# Access Compliance Report

## Public Rights-of-Way

### (Curb Ramps)

Intersection ID: 9246	Main Street: GRIMES_ST	Cross Street: NORRIS_AV	Location:	E
ADA ID: 4B64323A0650	Ramp Type: Perp	Initial Pass/Fail: Fail	Overall Compliance: No	Severity Score: 25

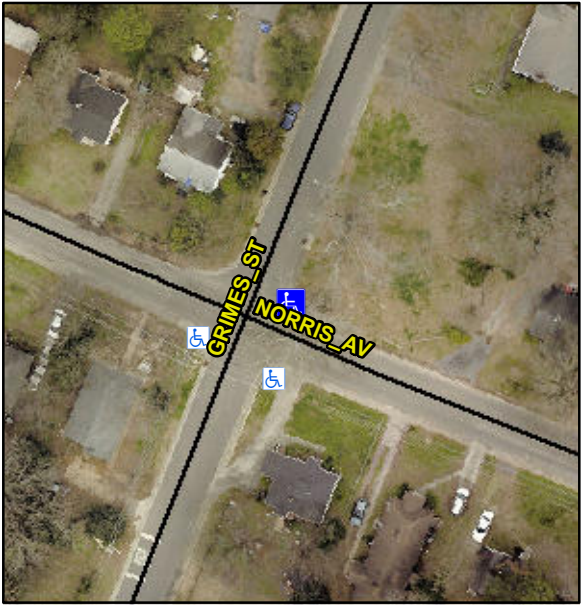
Codes/Mitigation Info/Possible Solution			Field Measurements/Component Compliance		
	Possible Solutions:		<b>Compliance</b>	<b>Description</b>	<b>Data</b>
	<b>Remove &amp; Replace Entire Ramp.</b>		<b>No</b>	Ramp Length (in)	53.0
			<b>Yes</b>	Ramp Width (in)	90.0
			<b>N/A</b>	Flare Type LT	N/A
			<b>N/A</b>	Flare Slope LT (%)	N/A
			<b>N/A</b>	Flare Traversable LT?	N/A
			<b>N/A</b>	Landing Length (in)	N/A
			<b>N/A</b>	Landing Width (in)	N/A
			<b>N/A</b>	Landing Slope (%)	N/A
			<b>N/A</b>	Landing X Slope (%)	N/A
<p>Surveyor Notes:</p> <p><b>N/A</b></p> <p>PROW/ADA:</p> <p><b>Not Found, R304.2.2</b></p>			<b>N/A</b>	Flare Type RT	N/A
			<b>N/A</b>	Flare Slope RT (%)	N/A
			<b>N/A</b>	Flare Traversable RT?	N/A
			<b>N/A</b>	DWS Provided?	N/A
			<b>N/A</b>	DWS Contrast?	N/A
			<b>N/A</b>	DWS Length (in)	N/A
			<b>N/A</b>	DWS Full Width?	N/A
			<b>N/A</b>	DWS Offset (in)	N/A
			<b>N/A</b>	Shared Landing?	N/A
